# Addressing the Proposed Overshoot Modification

- Comments #248, #249, #250 and #251

802.3dj interim

May 2026 Munich Germany

CI 180 SC 180.7.1 P468 L38 # I-248

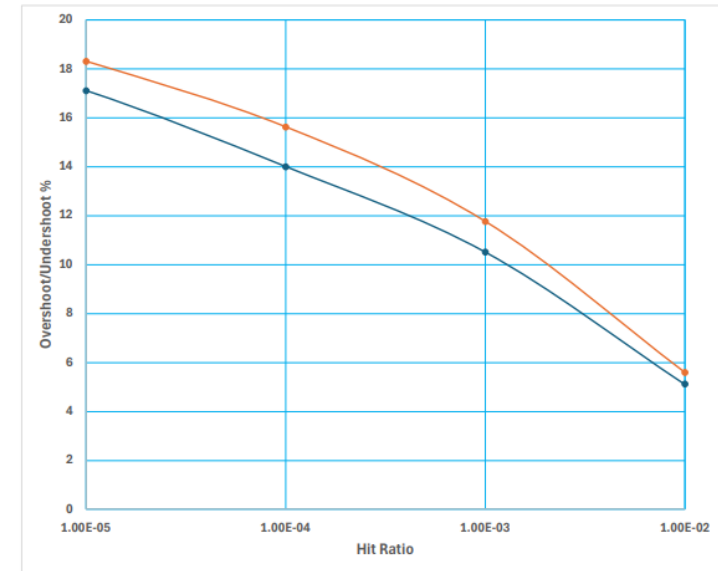
In D2.0 1T DFE was added to the TDECQ equalizer where DFE is superior to improve TDECQ for bandlimited transmitters over using large overshoot/undershoot which can have 1-2 dB of SNR penalty given TDECQ doesn't incorporate peak-to-average penalty. Overshoot/undershoot of 22% at 1E-2 hit ratio can also result in clipping and frame loss.

- Even for SSPRQ moderate size pattern (65,535 bits ) overshoot triples from ~5% at hit ratio of  $10^{-2}$  to ~15% at hit ratio of  $10^{-4}$ 
  - A typical transmitter with 15%, 20%, or 22% overshoot at  $10^{-2}$  hit where the overshoot is >50% at  $10^{-4}$  hit is problematic

Hit ratio of 1E-2 has no merits given SSPRQ and Ethernet scrambled data. Peak-peak amplitude for example are measured at hit ratio of 1E-7 in DJ. Change hit ratio from 1E-2 to 1E-4 and reduce overshoot/undershoot from 22% to 18% given that TDECQ has DFE no longer such high overshoots are necessary. see [ghiasi\\_3dj\\_02\\_2605](#)

**Ali's Proposal:** Reduce hit ratio from 1e-2 to 1e-4 and spec value change from 22% to 18%

# Overshoot/Undershoot Results

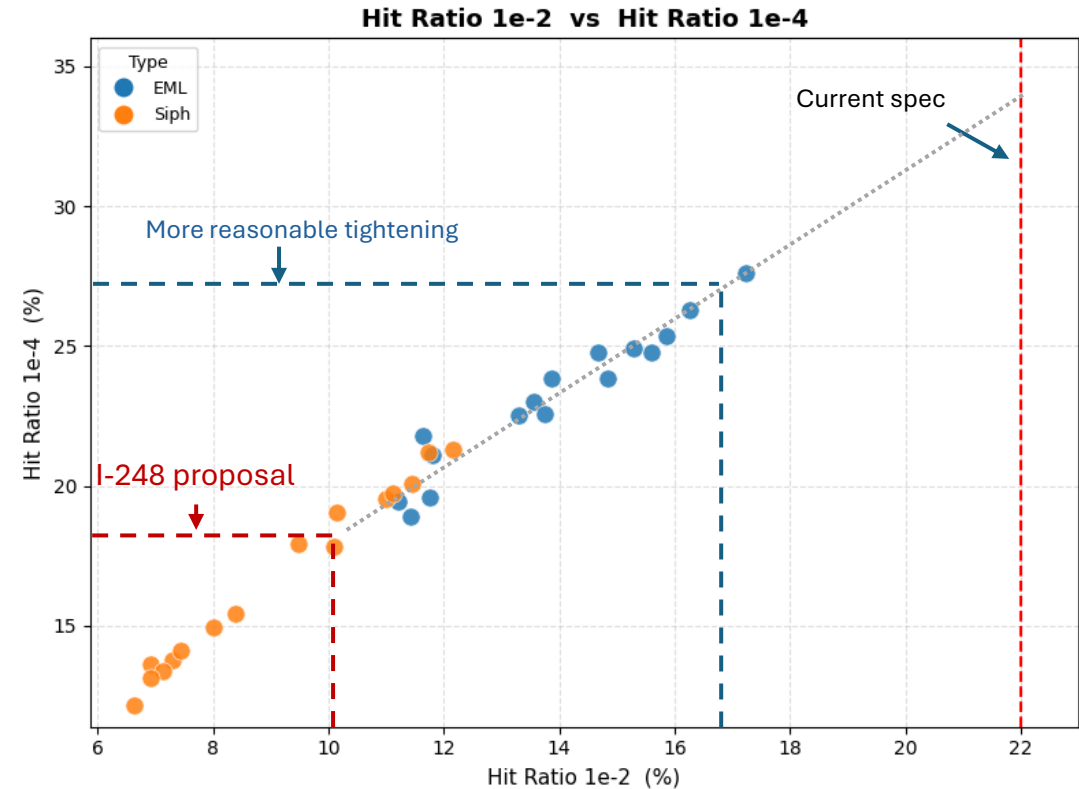
- The proposed tightening by Ali represents roughly a 55% reduction from the current overshoot specification. Such a reduction would significantly impact existing Tx implementations. Therefore, to make such change this late in the project, strong technical justification and evidence should be provided.
- While changing the hit ratio from  $1e-2$  to  $1e-4$  may improve the robustness of the specification, it should be paired with a corresponding adjustment to the allowable spec limit.
- **This presentation proposal:**
  - Adopt a hit ratio of  $1e-4$  with a spec limit of 27%
- A hit ratio of  $1e-4$  with a spec limit of 27% would address concerns about potential 50% overshoot claims noted in [ghiasi\\_3dj\\_01a\\_2603](#), while remain achievable for current designs

- I-248 proposes an aggressive change that could impact current implementations without sufficient data to demonstrate that it is technically necessary.
- A more balanced approach would be to set the overshoot limit to 27% at a  $1e-4$  hit ratio.
- Alternatively, the current specification should be maintained until a more comprehensive analysis is completed to justify the change.
